IN THE DRAWINGS

Changes to the drawings (relative to the original drawings) are as follows:

Figure 1

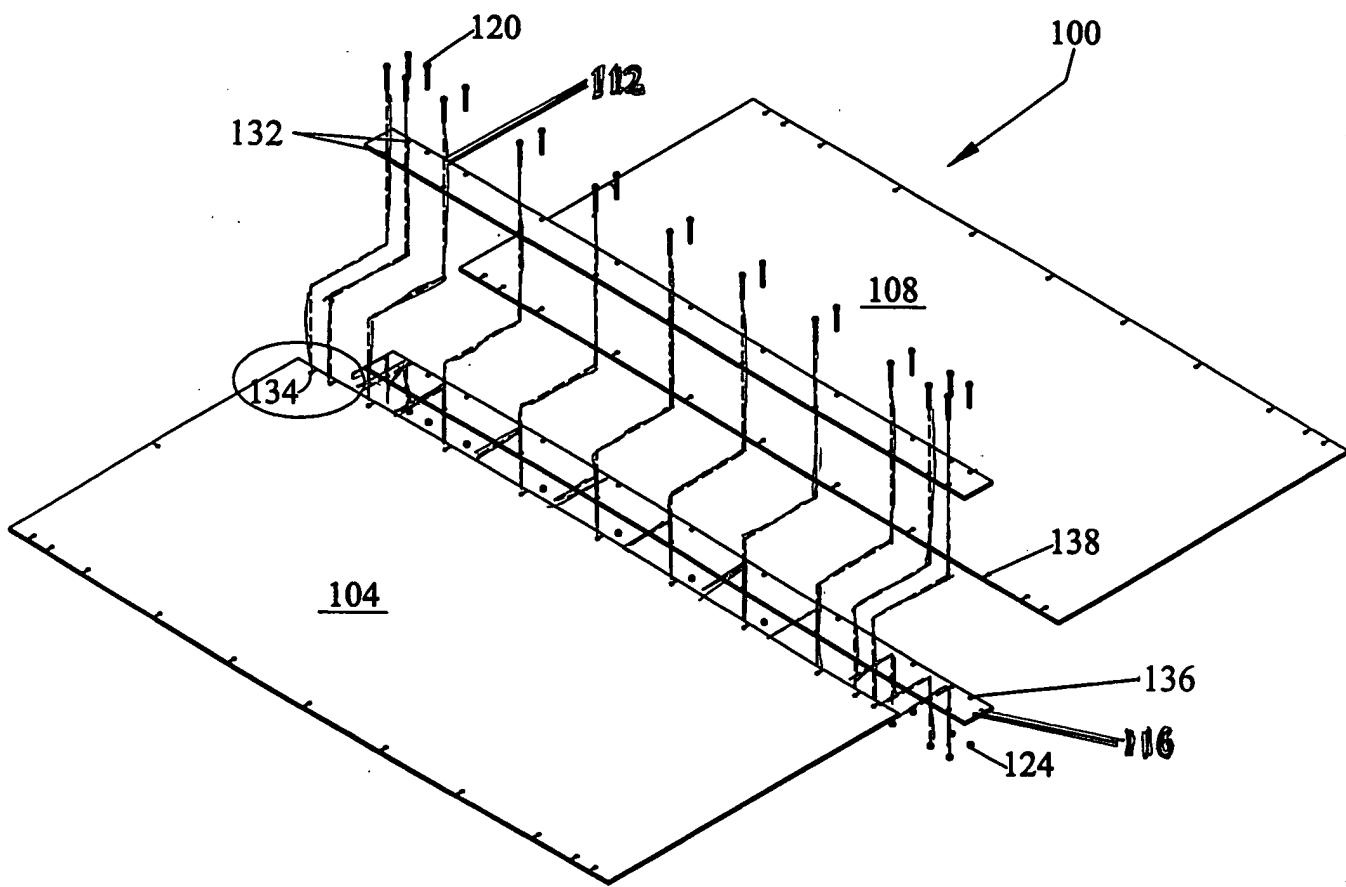
FIG. 1: Reference numerals 112 (facing strip) and 116 (backing strip) have been added. These structures are discussed at paragraph 32. Dashed assembly lines indicating how the structure is assembled have been added.

Figure 1A

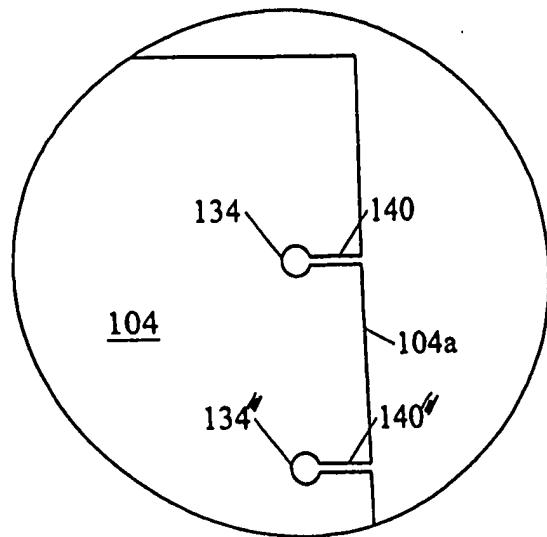
FIG. 1A: Numerals 134 and 140 for the second slot and hole have been changed to 134' and 140' as is consistent with the discussion at paragraph 37. Please note that FIG. 1A shows only a portion of plate 104, and does not show plate 108.

Figure 2

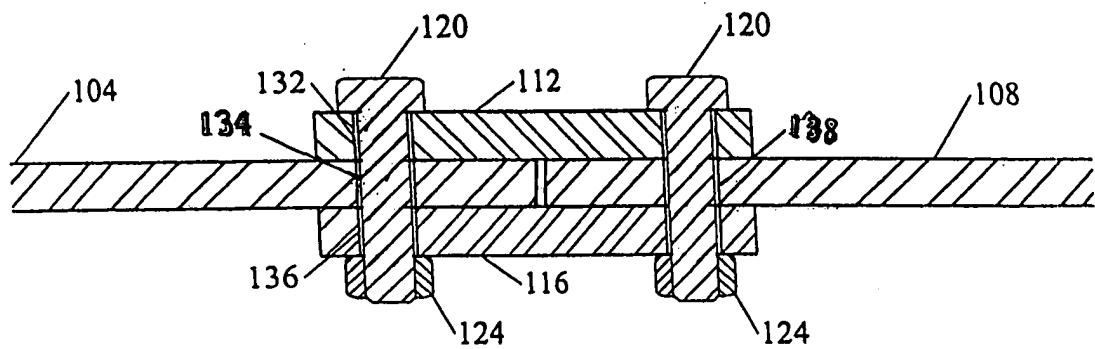
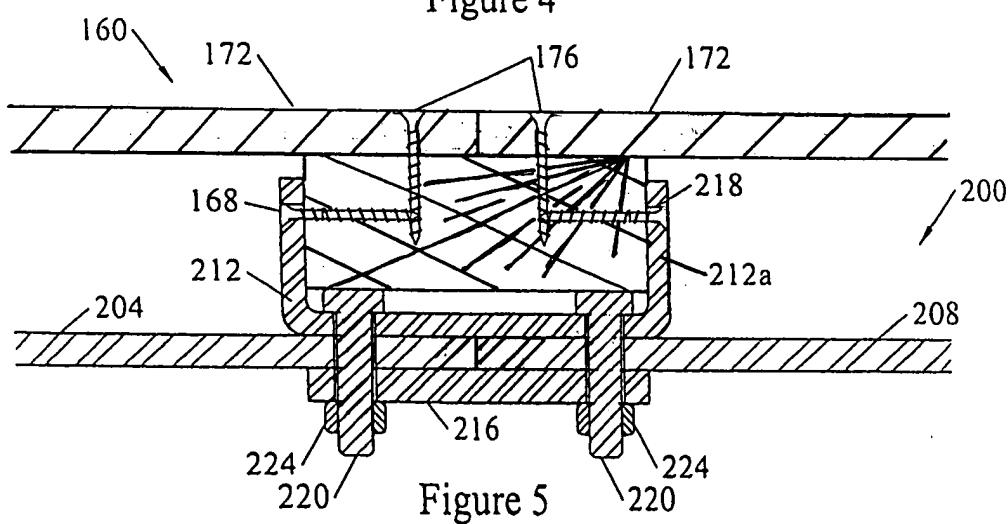
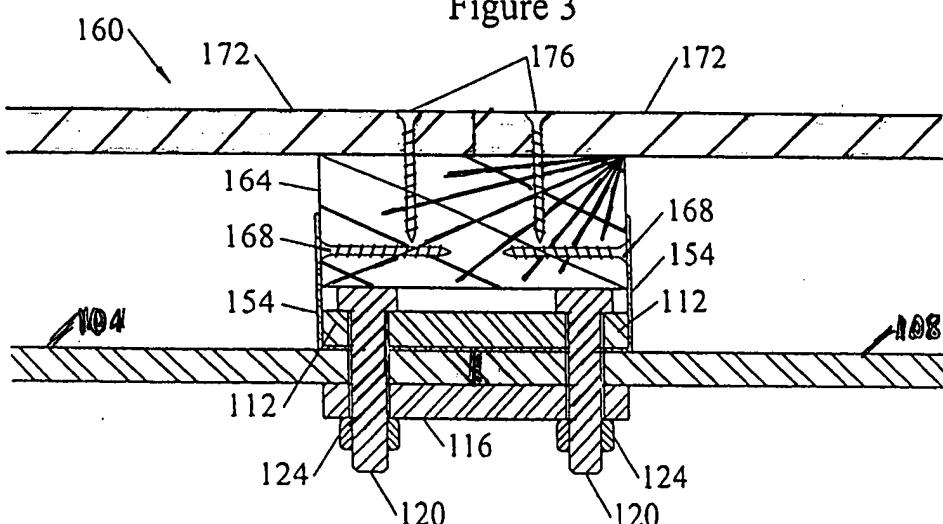
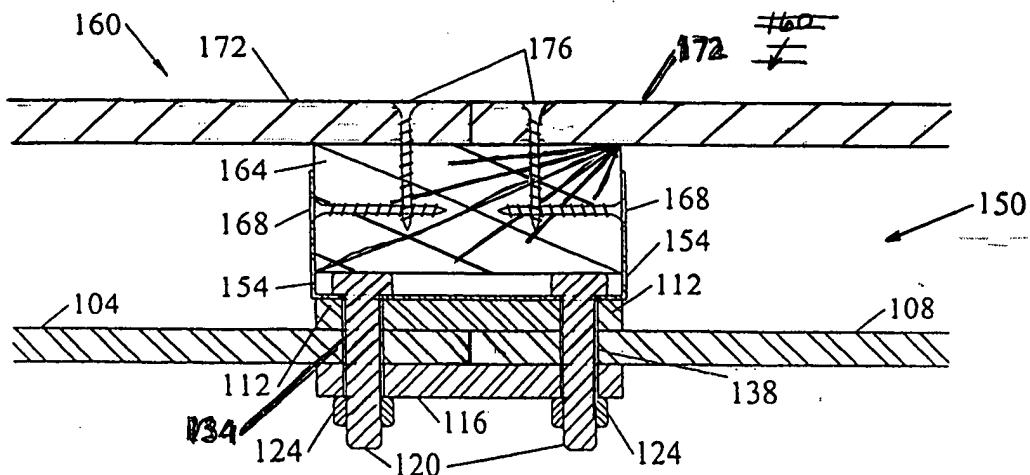
FIG. 2: Numerals 134 and 138 have been added to identify the holes in plates 104 and 108. Such is consistent with paragraph 38 and Figures 1 and 1A and related discussion.

Figure 3a (Prior Art)

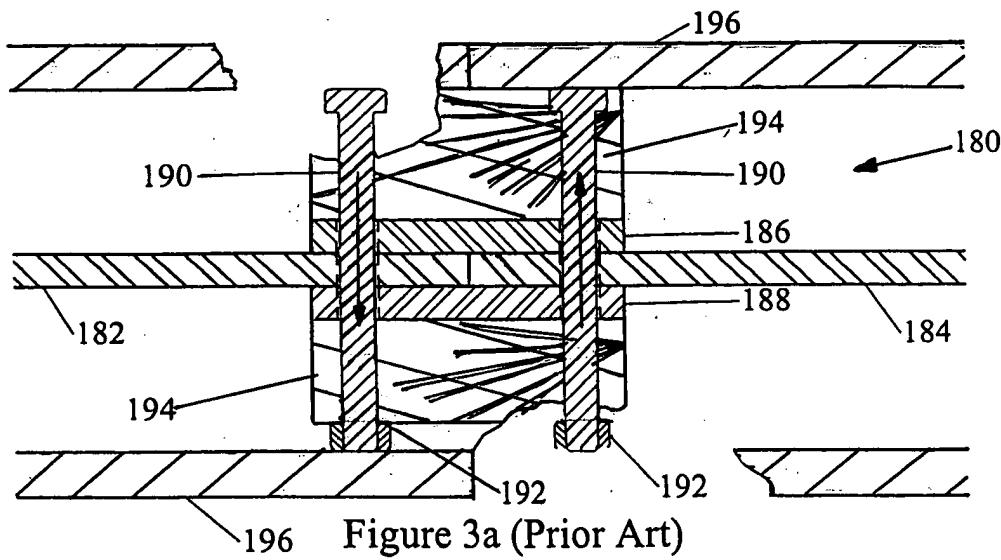
FIG. 3: Numeral 160 has been removed as it was shown twice in the original figures. Numerals 172 and 134 have been added for structures previously shown and identified in paragraph 42 and with respect to Figures 1 and 1A. The 2x4 164 has also been crossed hatched as wood, as discussed in the specification paragraph 41.

Figure 3b

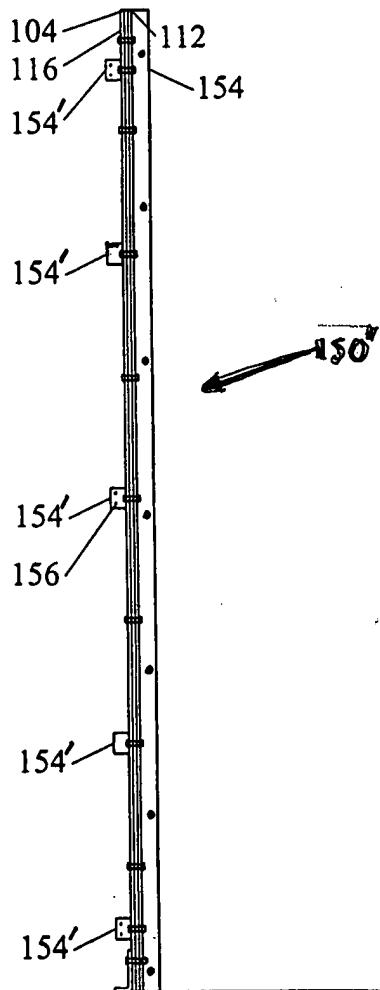
FIG. 3b: numeral 150' has been added as discussed in paragraph 48. The 2x4 164 has also been crossed hatched as wood.

Figure 6

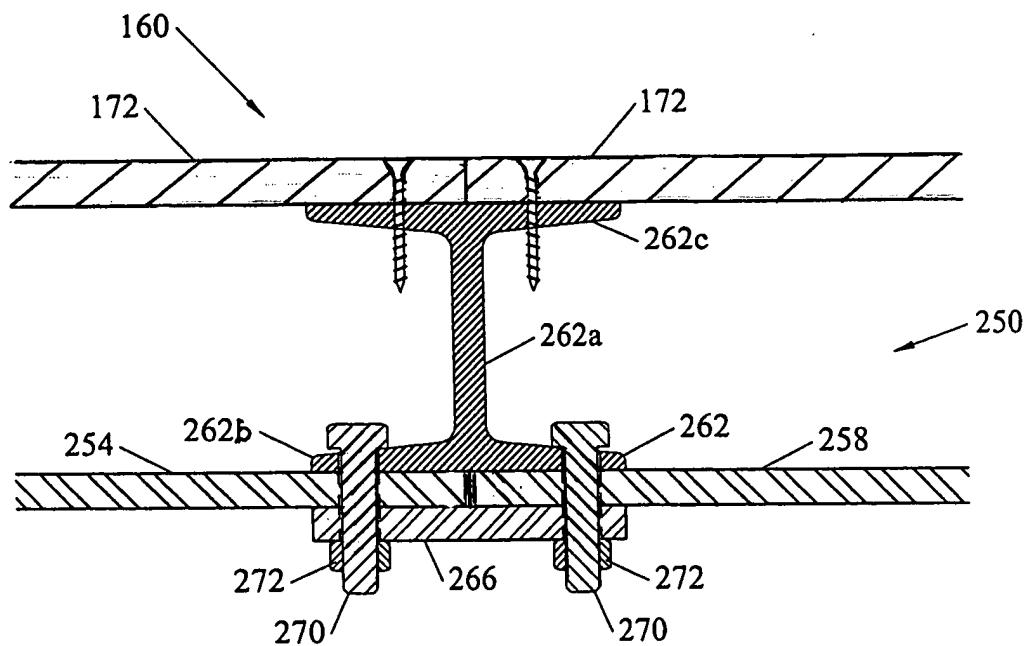
FIG. 6: The edges of plates 254 and 258 and resulting joint has been shown. This is discussed in paragraph 54.

Figure 7

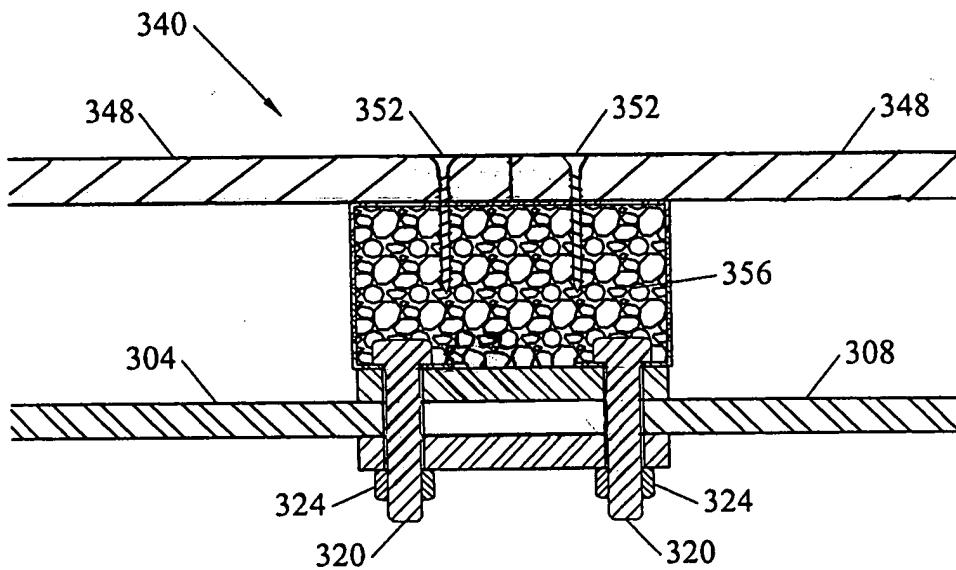
FIG. 7: FIG. 7 has been corrected to match the original drawing, as suggested by the Examiner.

Figure 8a

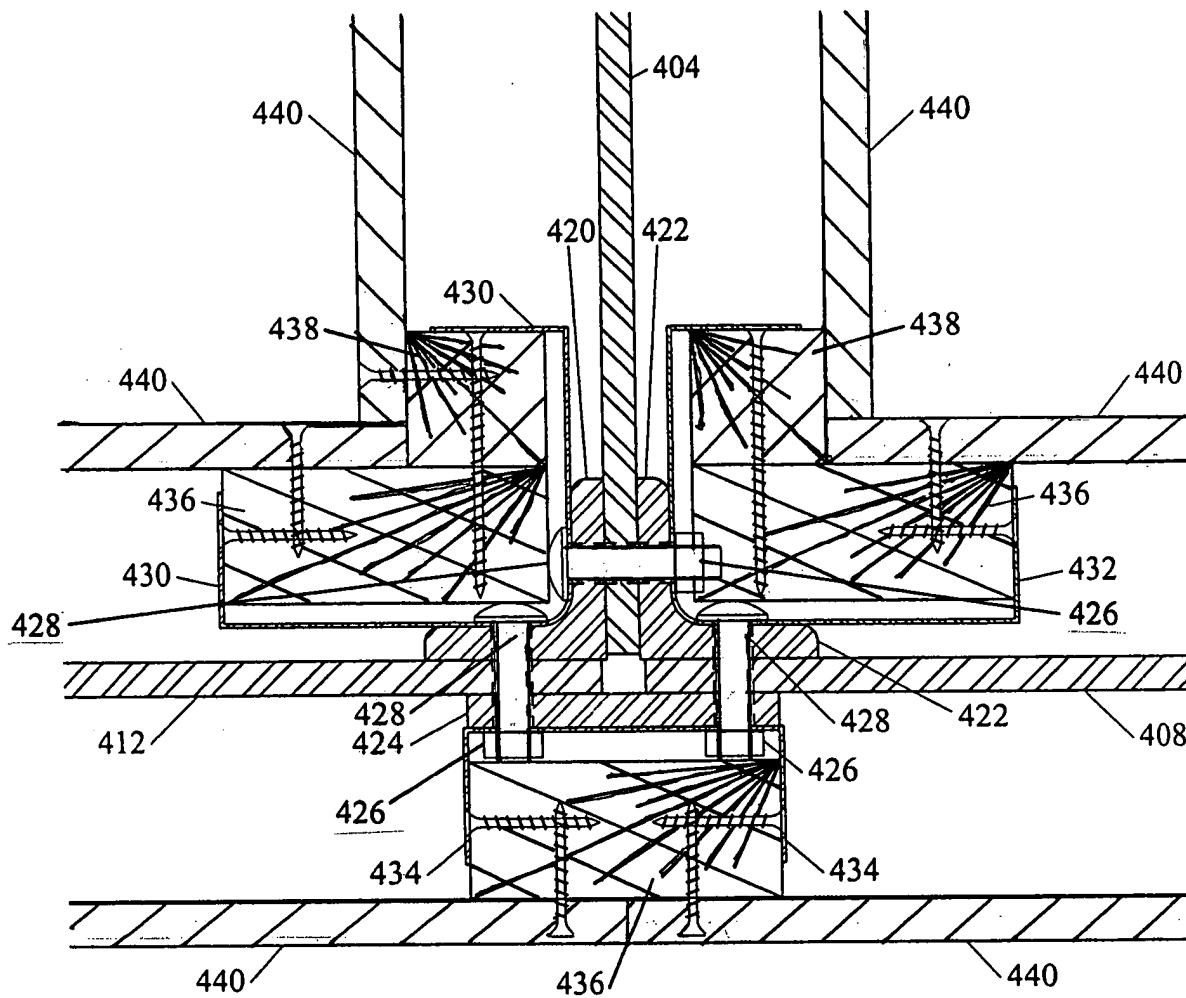
FIGs. 8a-8d: The 2x4's, 2x2's, and wood pieces shown have been crossed hatched as wood.

Figure 8b

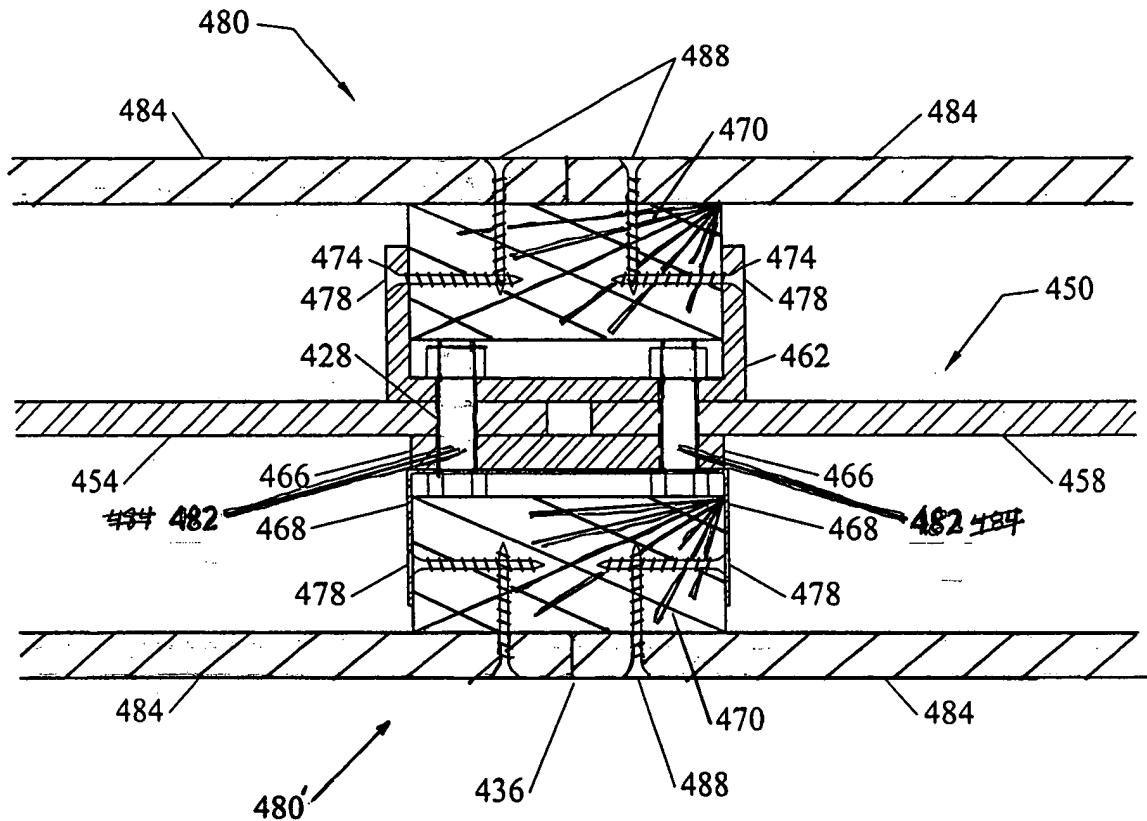
FIG. 8b: Reference numerals 484 (bolts) have been changed to 482. It was discovered that the number 484 was used for both the sheets of plywood as well as the bolts. Paragraph 68 of the specification has been correspondingly amended.

Figure 8c

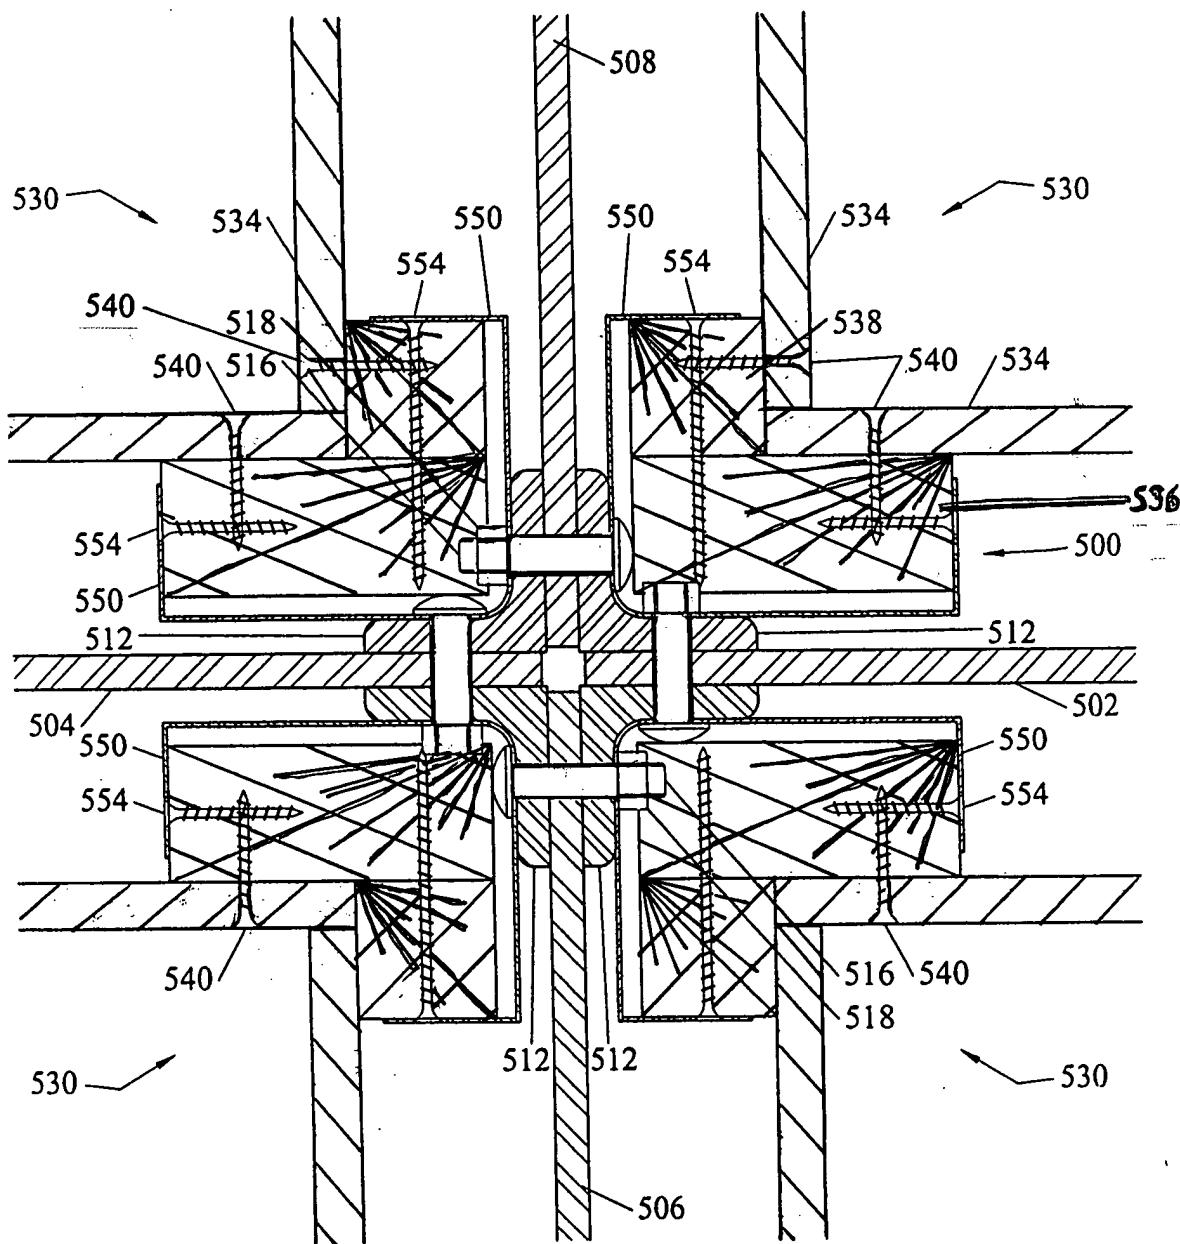
FIG. 8c: Reference number 536 has been added. Number 536 is used in paragraph 70 to describe the 2x4 support posts.
